Access Compliance Report

Public Rights-of-Way

(Curb Ramps)

Intersection ID: 5213	Main Street: NORTHPARK_BV	Cross Street: REAMES_RD	Location: S
ADA ID: A333AE2D28D4	Ramp Type: PerpDiag	Initial Pass/Fail: Fail	Overall Compliance: No
Codes/Mitigation Info/Possible Solution		Field Measurements/Component Compliance	
Severity Score: 21.25

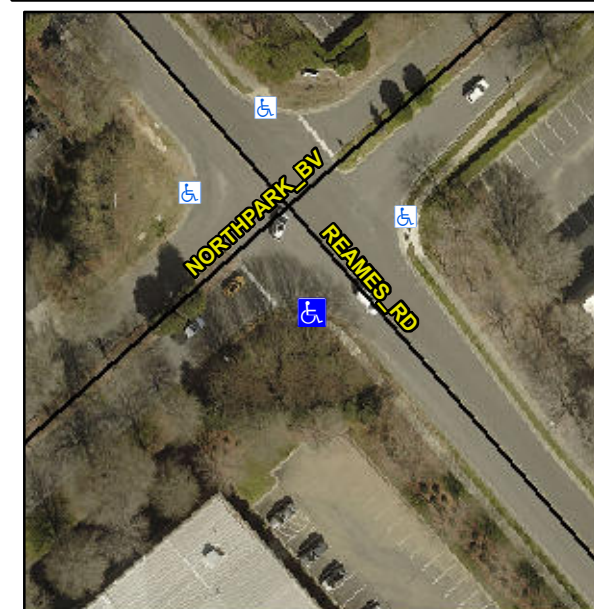
PROW/ADA:

R304.5.1, R304.2.2

Compliance	Description	Data	Compliance	Description	Data
N/A	Ramp Length (in)	52.0	No	Ramp Slope (%)	8.6
No	Ramp Width (in)	47.0	Yes	Ramp XSlope (%)	0.7
N/A	Flare Type LT	N/A	N/A	Flare Type RT	N/A
N/A	Flare Slope LT (%)	N/A	N/A	Flare Slope RT (%)	N/A
N/A	Flare Traversable LT?	N/A	N/A	Flare Traversable RT?	N/A
N/A	Landing Length (in)	N/A	N/A	DWS Provided?	N/A
N/A	Landing Width (in)	N/A	N/A	DWS Contrast?	N/A
N/A	Landing Slope (%)	N/A	N/A	DWS Length (in)	N/A
N/A	Landing X Slope (%)	N/A	N/A	DWS Full Width?	N/A
N/A	Landing Curb? (Y/N)	N/A	N/A	DWS Offset (in)	N/A
N/A	Shared Landing?	N/A			
N/A	Gutter Ponding?	N/A	N/A	Gutter Slope (%)	N/A
N/A	Gutter Lip Ht (in)	N/A	N/A	Gutter X Slope (%)	N/A
N/A	Painted X Walk1?	No	N/A	Painted X Walk2?	No
	X Walk 1 Direction	To NE		X Walk 2 Direction	To NW
N/A	X Walk 1 Width (in)	N/A	N/A	X Walk 2 Width (in)	N/A
	X Walk 1 Slope (%)	2.3		X Walk 2 Slope (%)	3.7
	X Walk 1 X Slope (%)	8.4		X Walk 2 X Slope (%)	3.6

N/A	Ramp inside XWalk1?	N/A	N/A	Ramp inside XWalk2?	N/A
	Road Slope (%)	4.2	N/A	Clear Space?	N/A
	Road X Slope (%)	2.5	N/A	Clear Space to XWalk (in)	N/A
N/A	Any Obstructions?	N/A	N/A	Storm Grate/Utility Hazard?	N/A
	Obstruction Type			Storm Grate/Utility Type	
		N/A			N/A
			Yes	Surface Condition? (G/P)	Good

Remove & Replace Curb Ramp With Two New Directional Ramps or Equivalent.
